# Edge2 V7 Release Note

2024/11/07 Corrected document v1.2

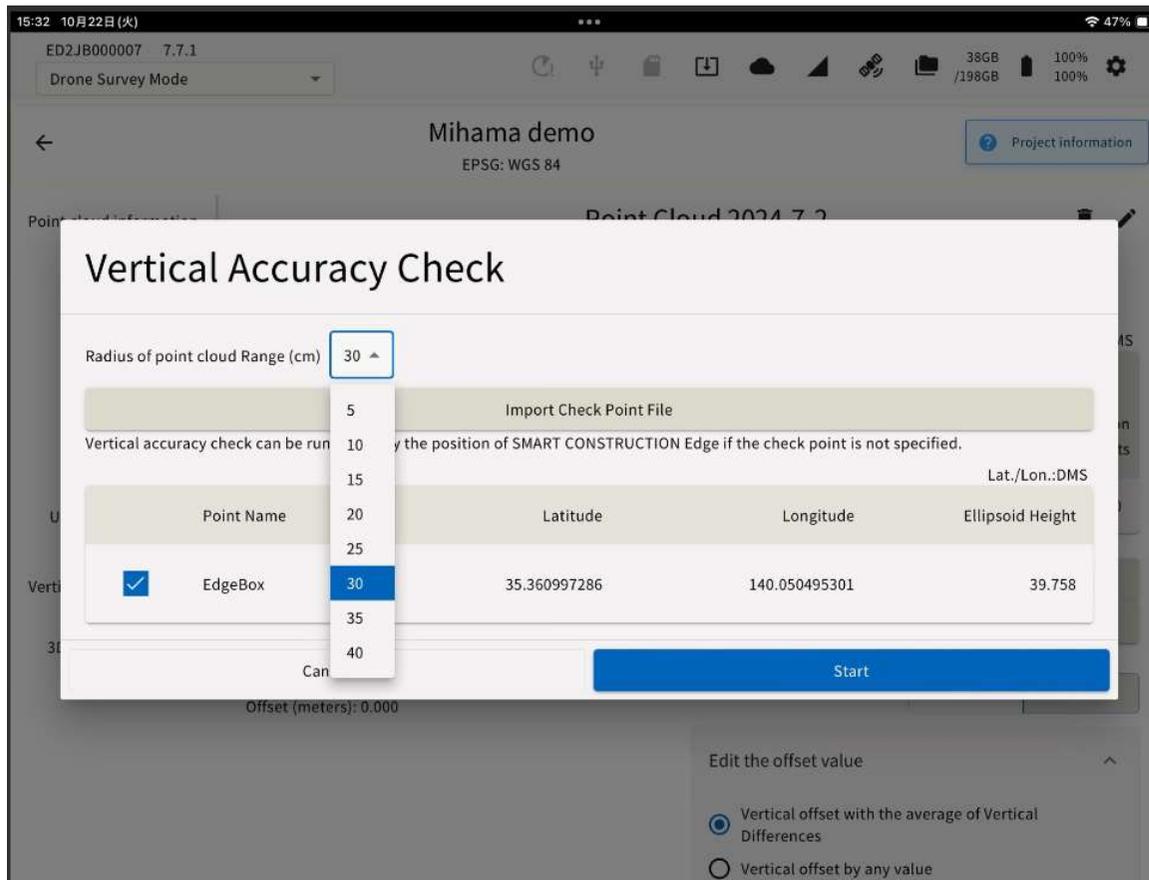
In the "Vertical accuracy verification" function, the radius of the point cloud search area can now be set up to 40 cm in 5 cm increments.

## World file export specifications

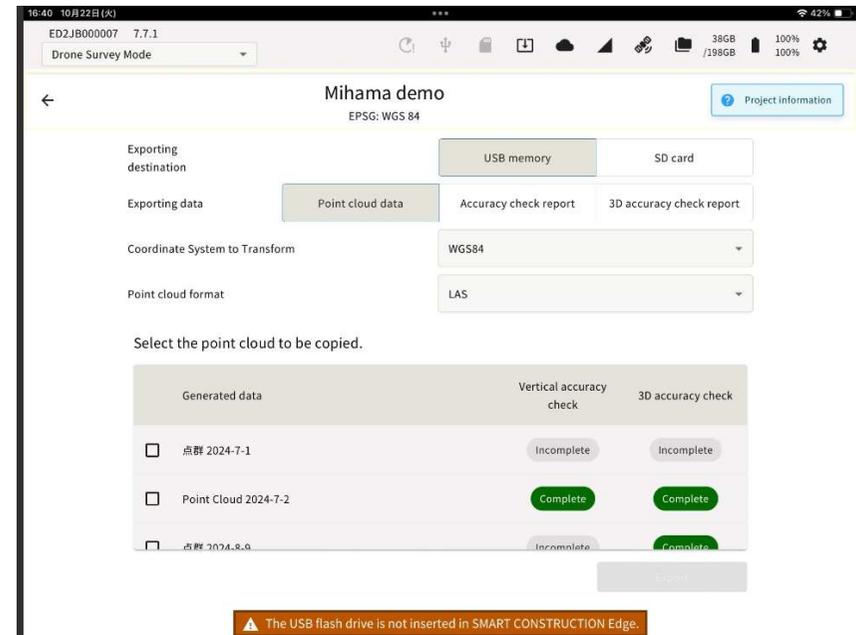
No changes to the UI:  
If an ortho has been generated, (.tfw file) will be automatically output.

## Status Bar

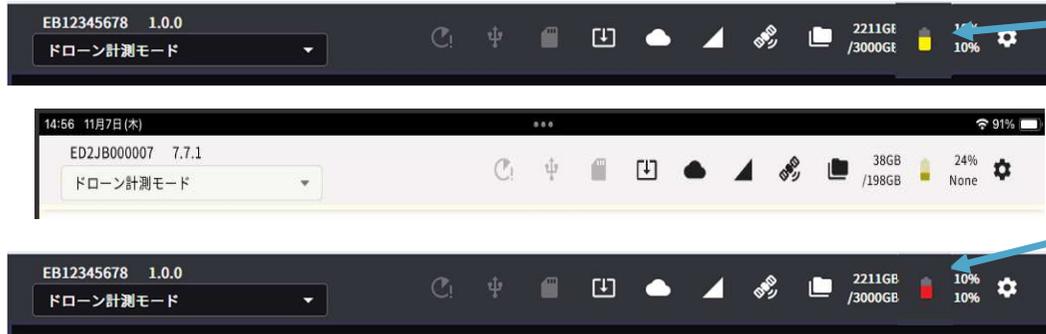
The color of the battery icon changes when the remaining battery charge falls below the specified level.

Battery level below 50%.

Battery level is below 20% A warning is also displayed in the UI below.

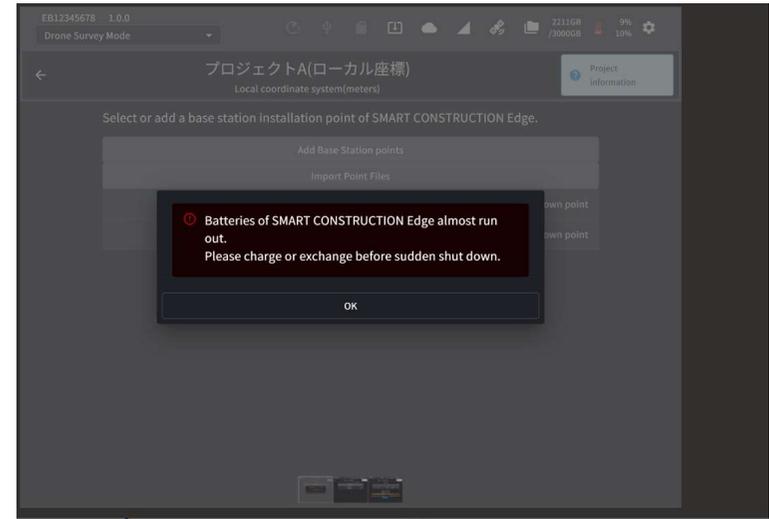
**Red blinking of the 4-way LED will start when the remaining capacity falls below 20%.**

\*When performing point cloud processing, even before the battery level turns red

The voltage may drop suddenly and the system may go into a red blinking shutdown.

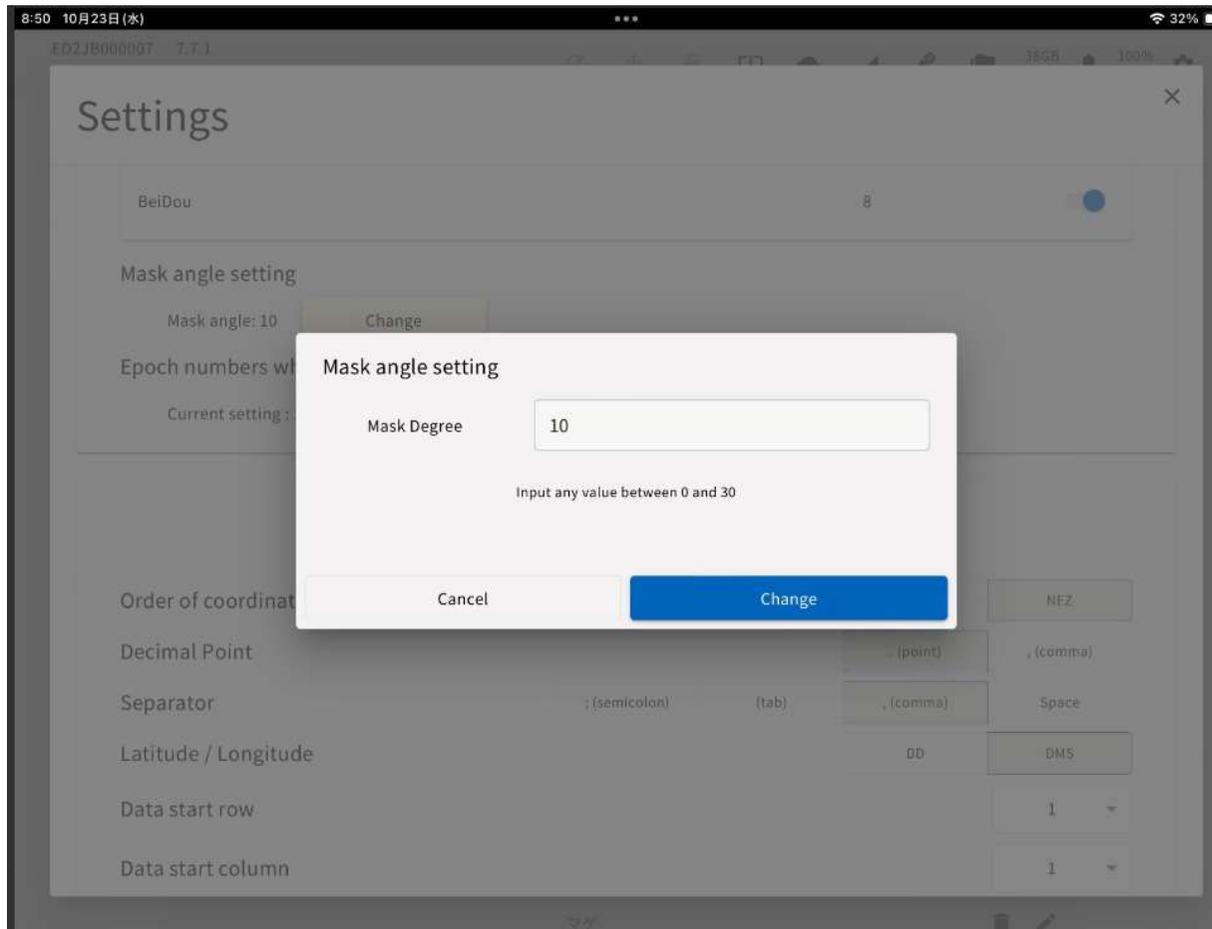
The mask angle setting angle can now be changed in 1-degree increments from 0-30 degrees.

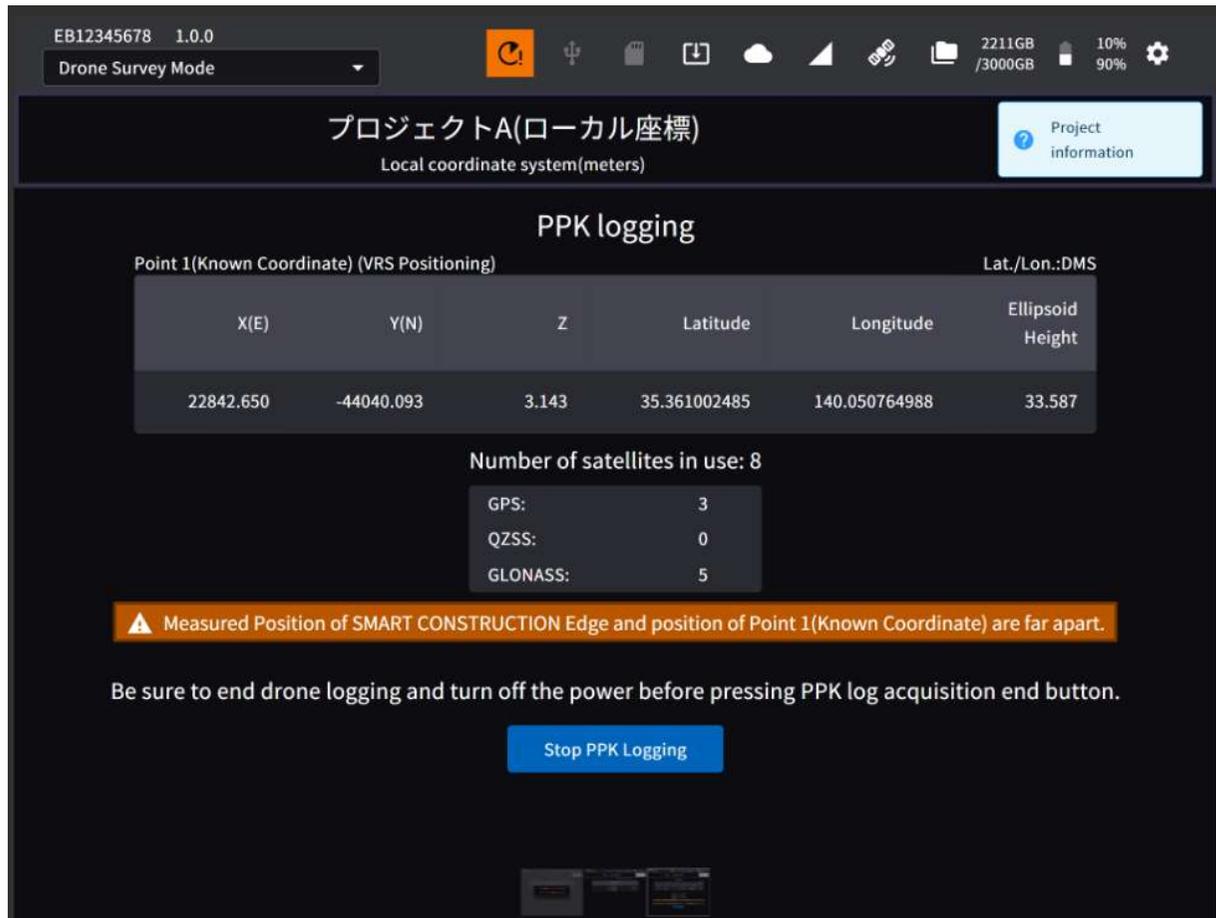
It is now possible to report an error if the XY coordinates of the self-position are significantly off when PPK logging starts.

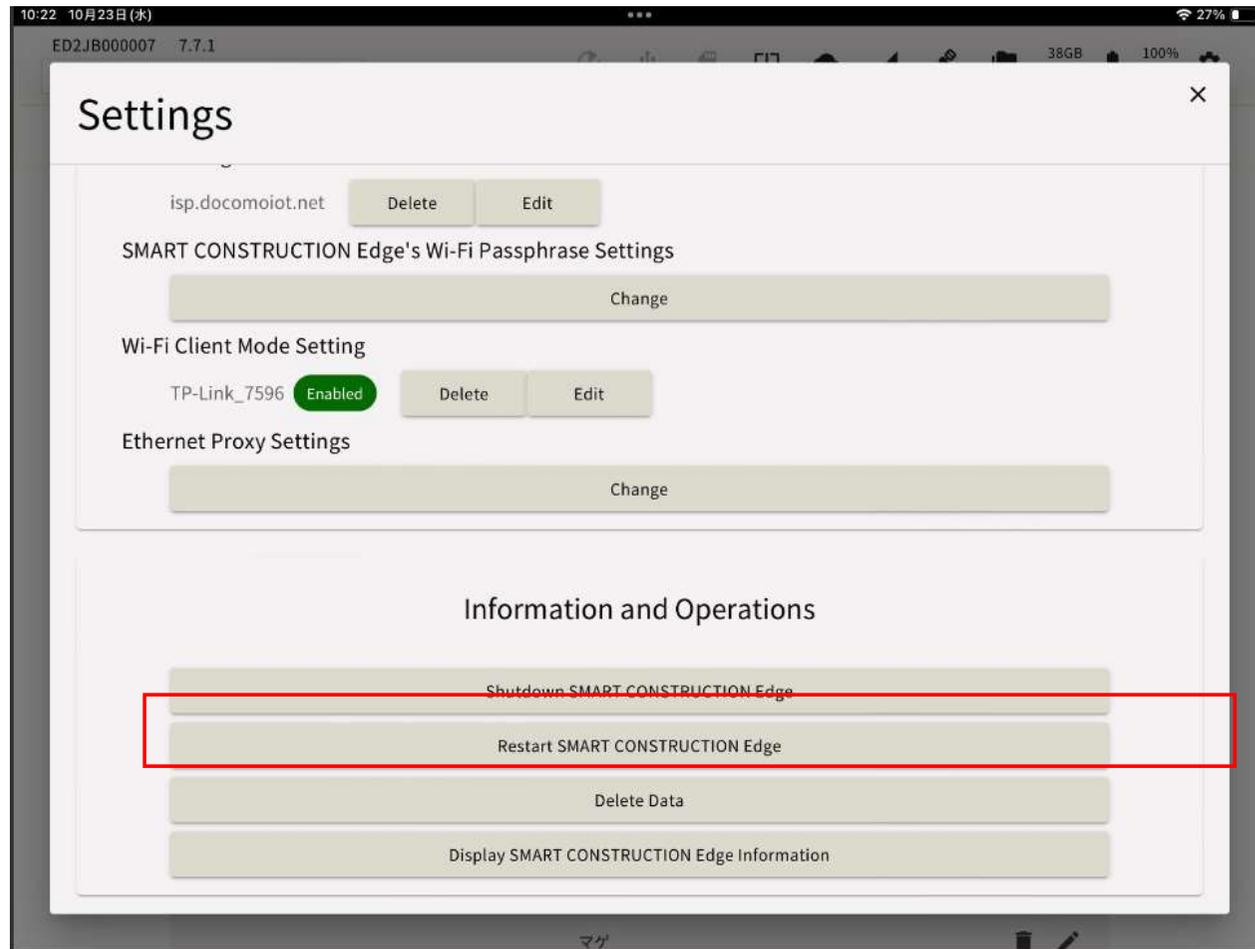
A restart icon has been added to enable restarting
